**SUSQUEHANNA STEAM ELECTRIC STATION
PROPOSED LICENSE AMENDMENT NO. 285
FOR UNIT 1 OPERATING LICENSE NO. NPF-14
AND PROPOSED LICENSE AMENDMENT NO. 253
FOR UNIT 2 OPERATING LICENSE NO. NPF-22
EXTENDED POWER UPRATE APPLICATION
REGARDING CHANGE TO
TECHNICAL SPECIFICATION SR 3.7.1 –
RESIDUAL HEAT REMOVAL SERVICE WATER
(RHRSW) SYSTEM
AND THE ULTIMATE HEAT SINK (UHS)
PLA-6266**

**Docket Nos. 50-387
and 50-388**

The purpose of this letter is to revise the proposed change to Technical Specification (TS) 3.7.1 contained in Reference 1 based on discussions held with the NRC staff on August 23, 2007.

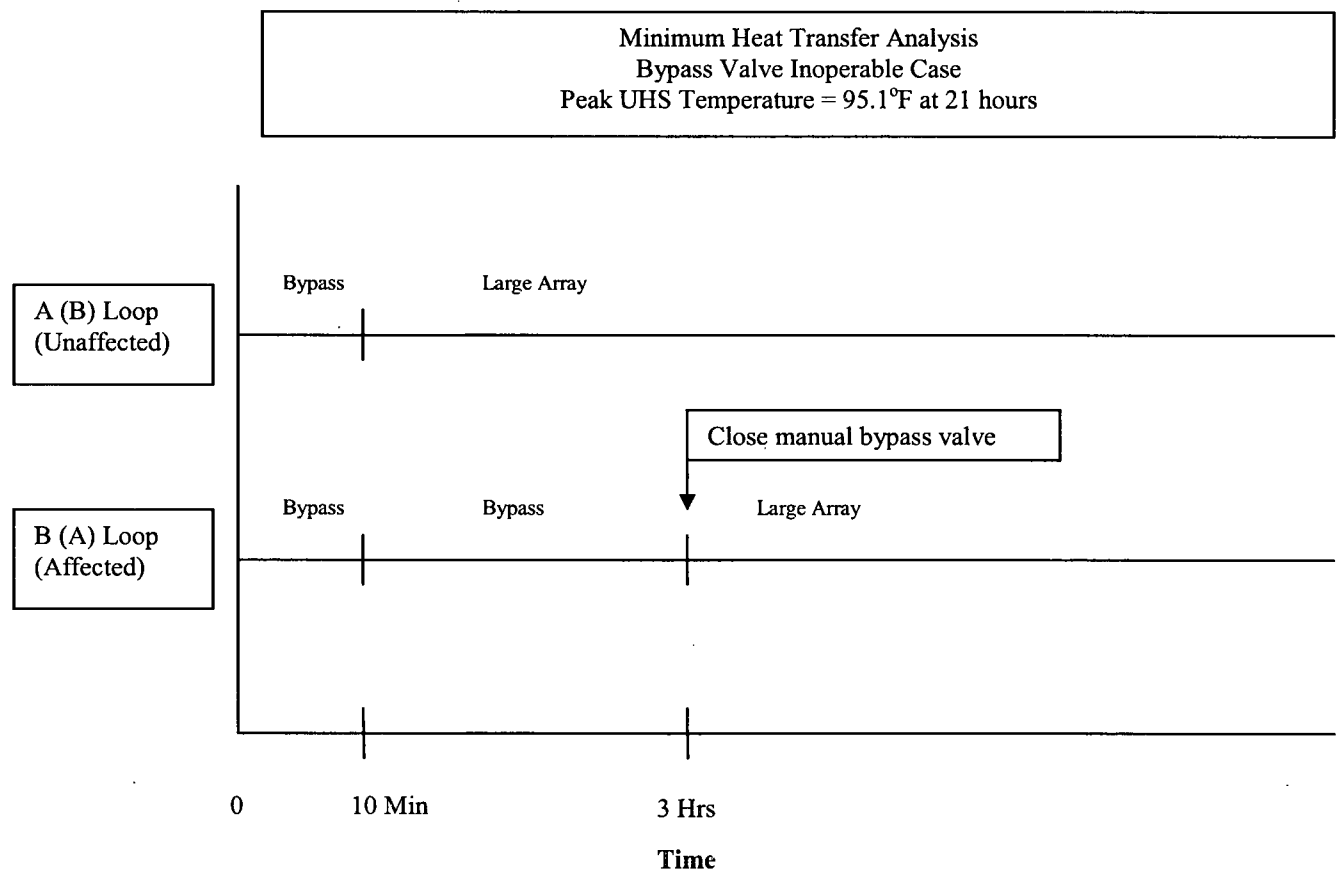
The design basis analysis for the UHS demonstrating existing spray capacity is summarized in Reference 1, Attachment 4, Section 4.5.1. The figures that follow the below discussion of the analysis depict the flow paths that are assumed for the UHS design base analysis. These analyses demonstrate the UHS has sufficient spray capacity.

The Minimum Heat Transfer Cases assume meteorological conditions that maximize peak pond temperature. The Maximum Water Loss Case assumes meteorological data that maximizes water loss.

For all cases, a LOCA and simultaneous shutdown of the other unit is assumed. A loss of offsite power to both units is also assumed. UHS temperature is maintained below the 97°F UHS design maximum temperature for the entire 30-day transient for all cases. In addition, all cases demonstrate that adequate UHS inventory exists to provide cooling for 30 days without makeup.

Minimum Heat Transfer Analysis
Large Spray Array Valve Inoperable Case

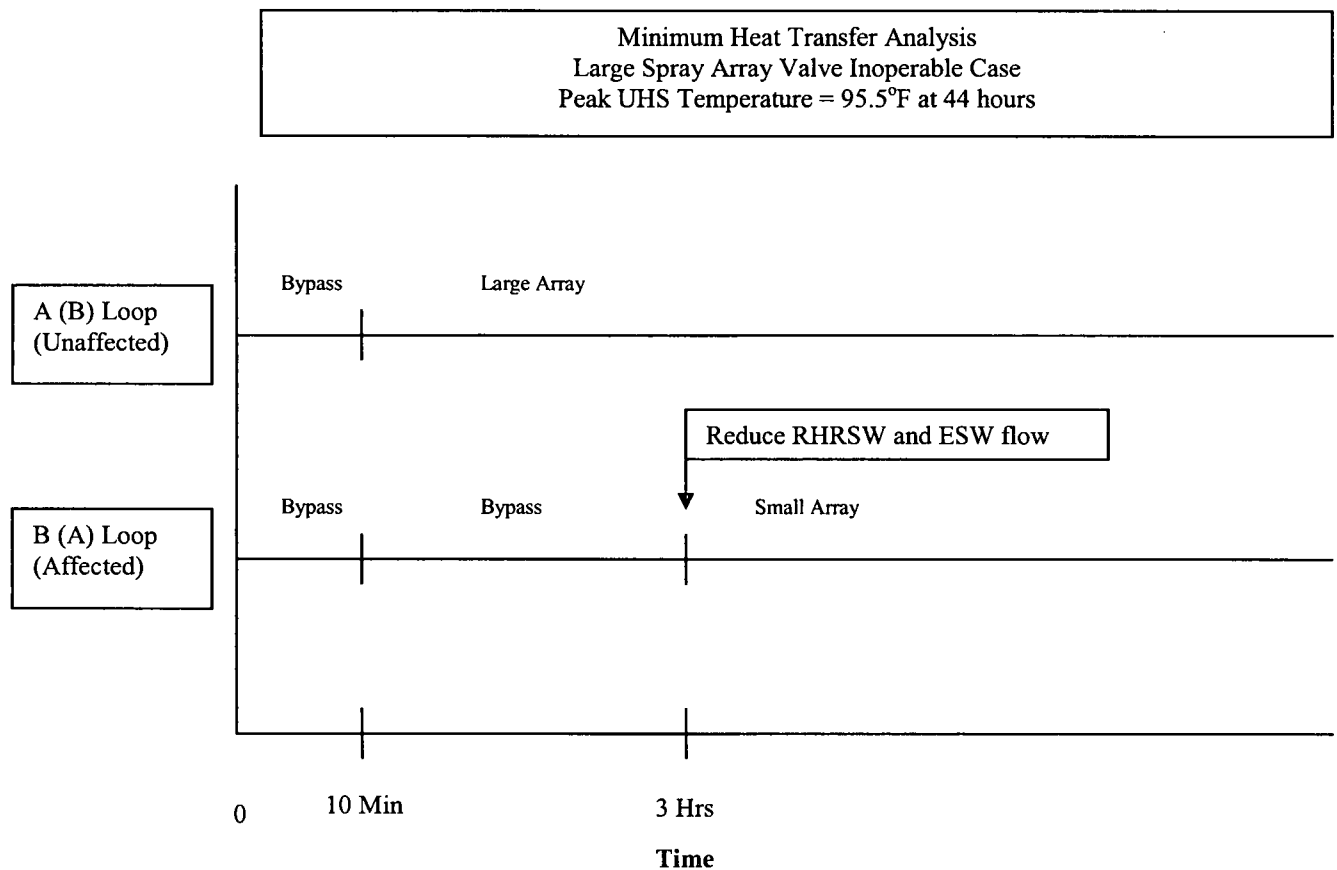
For this case, a large spray array valve is assumed to be inoperable in the closed position ("affected" loop). Heat is rejected to the UHS through both bypass lines at the beginning of the transient. On the unaffected loop, the large spray array valve is opened and the motor operated bypass valve is closed at 10 minutes to establish spray cooling. On the affected loop, flow continues through the bypass line for three hours. At three hours, RHRSW and ESW flow are reduced on the affected loop, the small spray array valve is opened and the motor operated bypass valve is closed to establish spray cooling. Spray cooling using a large spray array on one loop and a small spray array on the other loop continues for the balance of the transient.

Minimum Heat Transfer Analysis One Loop Inoperable Case

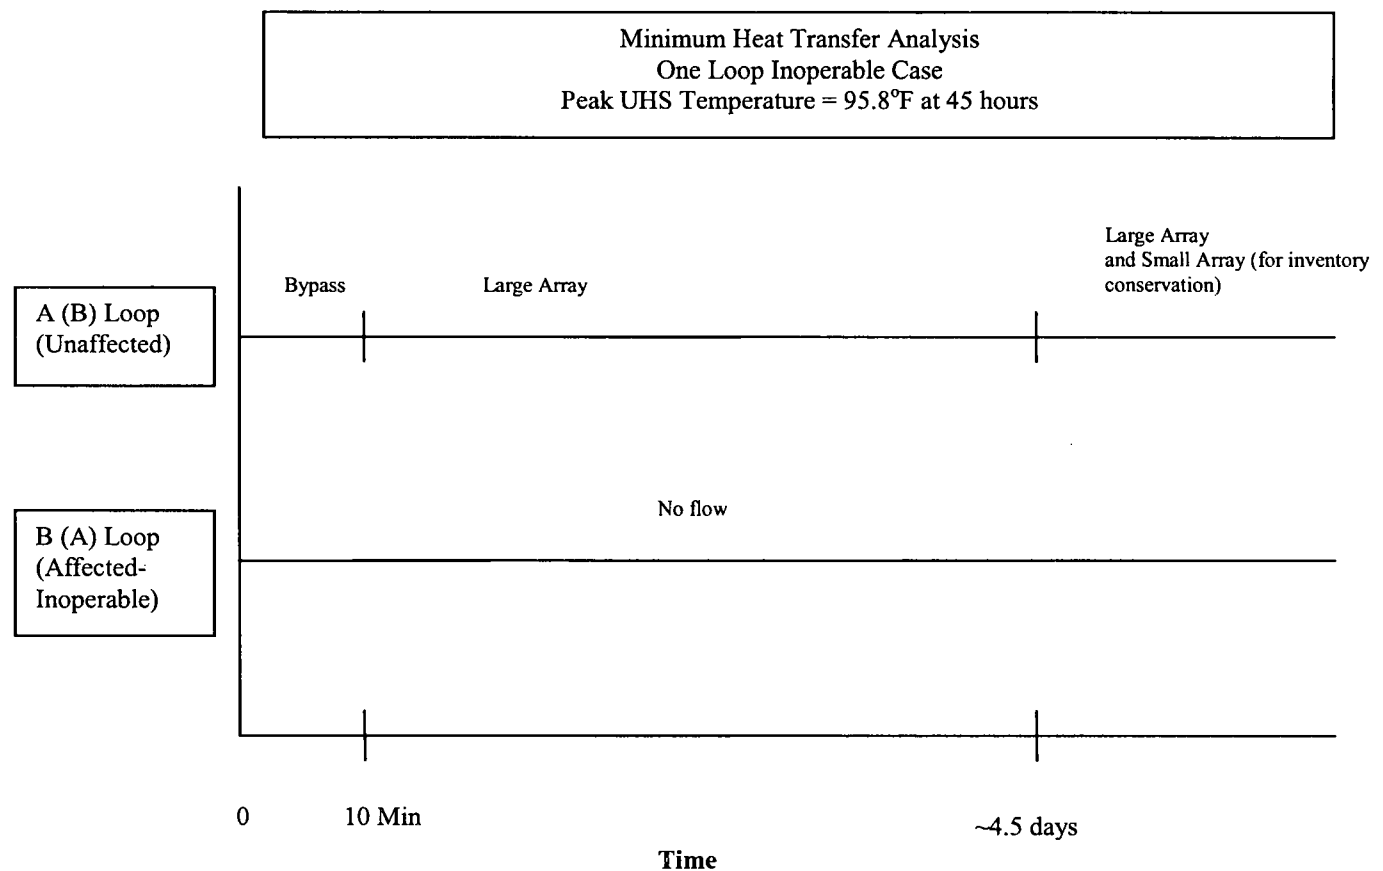
For this case, an entire loop of RHRSW and ESW is assumed to be inoperable ("affected" loop). No flow is assumed to exist in the affected loop for the entire transient. On the unaffected loop, heat is rejected to the UHS through the bypass line at the beginning of the transient. At 10 minutes, the large spray array valve is opened and the motor operated bypass valve is closed to establish spray cooling. Spray cooling using the large spray array continues until the small spray array valve is opened in order to conserve water inventory. Spray operation continues using both spray arrays in the same loop for the balance of the transient.

Maximum Water Loss Case

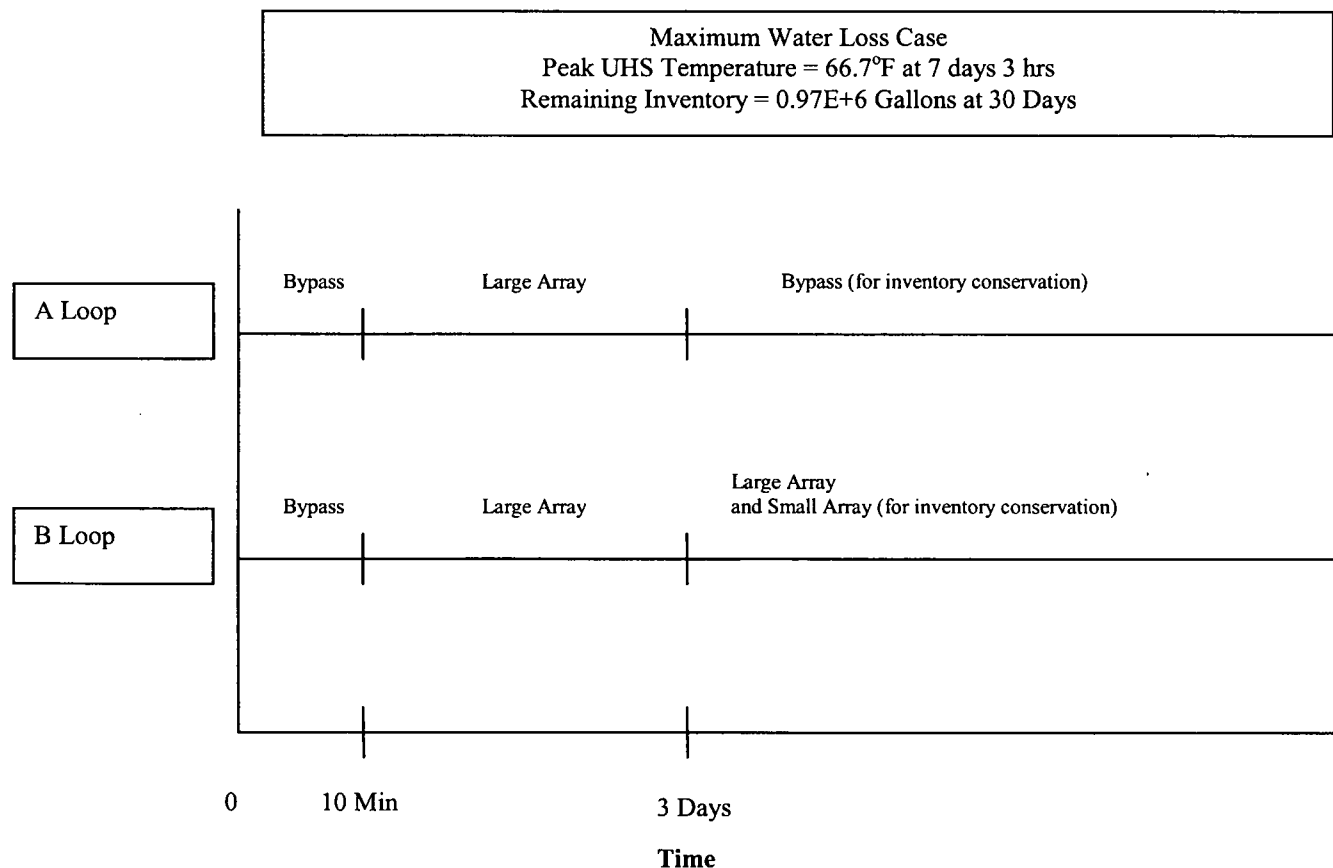
All equipment is assumed to be OPERABLE for this case. Heat is rejected to the UHS through both bypass lines at the beginning of the transient. At 10 minutes, the large spray array valves are opened and the motor operated bypass valves are closed to establish spray cooling on both loops. Spray operation continues on both loops using the large spray arrays until actions are taken to reduce spray evaporation and drift losses. These actions involve the use of the small spray array on one loop (in addition to the large spray array) and the use of the bypass line on the other loop (no sprays). Under worst case conditions, these actions will take place in approximately 3 days. Operation will continue in this configuration for the balance of the transient.
